PLATTING BOARD AGENDA **ASSEMBLY CHAMBERS** **350 E DAHLIA AVENUE PALMER**

PLATTING BOARD MEETING **1:00 P.M.** **July 3, 2024**

A. **WILLIWAW #2 B7 L5-6 UE**: The request is to vacate the 10' Public Use Easements on **Lots 5 & 6, Williwaw #2** Plat #W-76. The property is located directly south of N. Tanana Drive and west of N. Copper Creek Road; (Tax ID's 1069B07L005 & 1069B07L006); located within the NE ¼ Section 2, Township 17 North, Range 01 West, Seward Meridian, Alaska. In the North Lakes Community Council and in Assembly District #4. (Petitioner/Owner: Precision Frontiers LLC, Staff: Chris Curlin, Case # 2024-063)

B. **CELESTIAL HEIGHTS**: The request is to create 56 lots and 1 tract from Tax Parcel B2 in a five-phase master plan, to be known as **CELESTIAL HEIGHTS**, containing 80.00 acres +/- . The parcel is located east of N. Palmer-Fishhook Road and directly south of E. Boyd Road, in Section 12 (Tax ID# 118N01E12B002); within Section 12, Township 18 North, Range 01 East, Seward Meridian, Alaska. The property is within the Fishhook Community Council and Assembly District #1. (Petitioner/Owner: SOA Mental Health Trust Land Office, Staff: Natasha Heindel, Case # 2024-068

CELESTIAL HEIGHTS SUBDIVISION	
DRAINAGE PLAN	
SCALE:	DATE: 4/12/24
ACCT. NO.	GRID:
SHEET 03	of 14

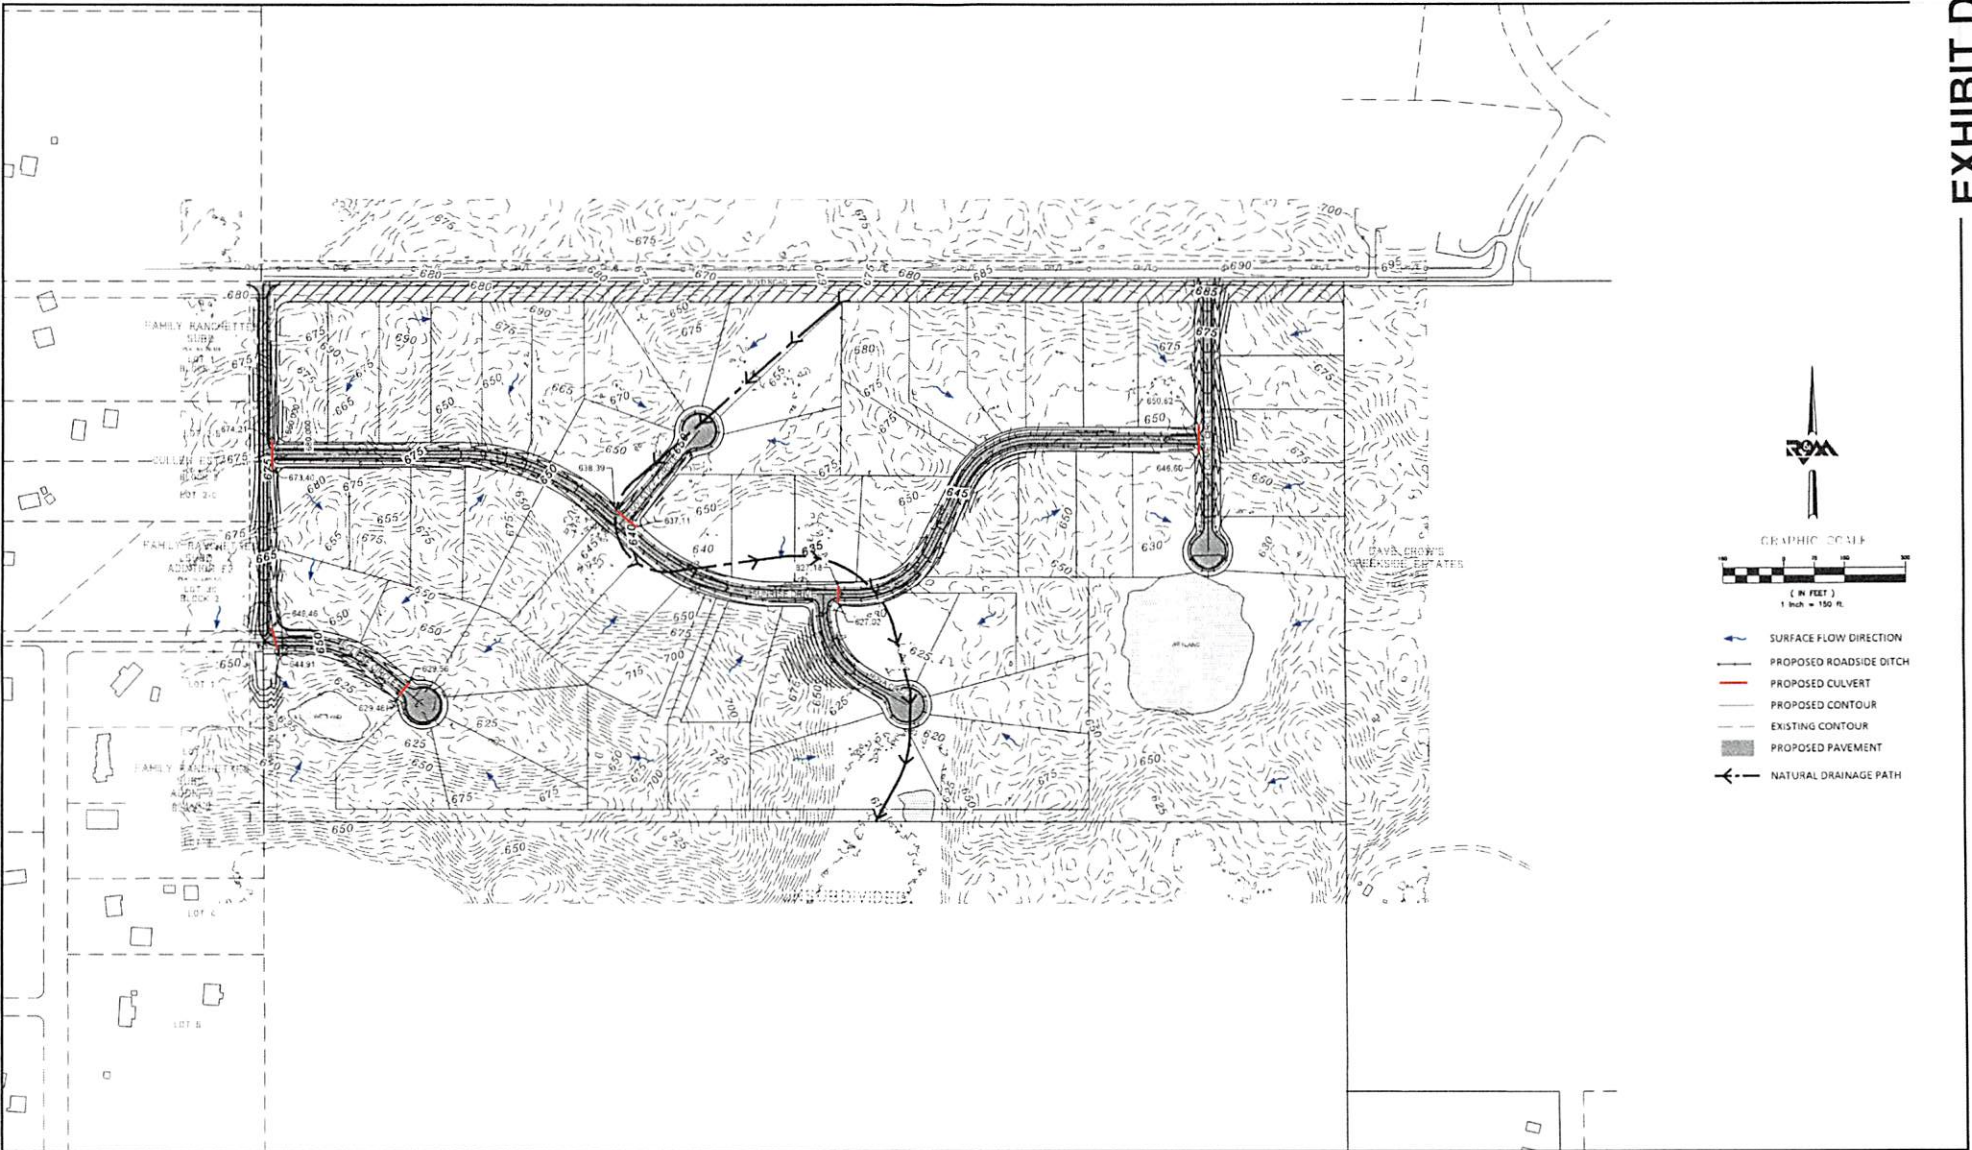
Comments: MSB Public Works Department, Division of Pre-Design & Engineering (PD&E) (**Exhibit G**) commented that the applicant will need to submit an ADT estimate including figures or tables showing breaking down ADT at each intersection within the Subdivision and en route to a residential minor collector street or higher; in this case Palmer-Fishhook Road as Boyd Road is currently classified as a residential sub collector. *Staff notes that R&M Consultants has provided an estimated ADT count (**Exhibit E**).* Based on the Archangel Ridge Subdivision Master Plan, it appears that Lot 1, Blockfontein will not have access from Archangel Ridge Subdivision. Based on a review of the topography and wetlands, PD&E is okay without a stub road going from the subject parcel to Lot 1, Blockfontein. Verify the section line easement to the west and have surveyor provide documentation of SLE verification. *Staff notes that R&M Consultants has provided SLE documentation (**Exhibit F**).* As a large portion of the site drains to Nova Circle, PD&E notes that there should be a cross culvert provided across Nova Circle at the intersection with Sunrise Drive (*see recommendation #3*). To satisfy the requirements of SCM D03, drainage easements will need to be dedicated for all proposed drainage paths/structures (*see recommendation #4*). Design the drainage so that water is not planned to be detained/infiltrated in the road ROWs (*see recommendation #5*). Recommend adding 15' utility easements along all ROWs (*see recommendation #6*). *Staff notes that surveyor is aware of said recommendations and plans to refine the design after receiving comments from the platting review and plan for drainage easements based on actual drainage routes.*

3. Provide a cross culvert across Nova Circle at the intersection with Sunrise Drive.
4. Dedicate drainage easements for all proposed drainage paths and structures.

5. Design the drainage so that water is not planned to be detained/infiltrated in the road rights of way.
6. Grant 15' utility easements along all road rights of way.
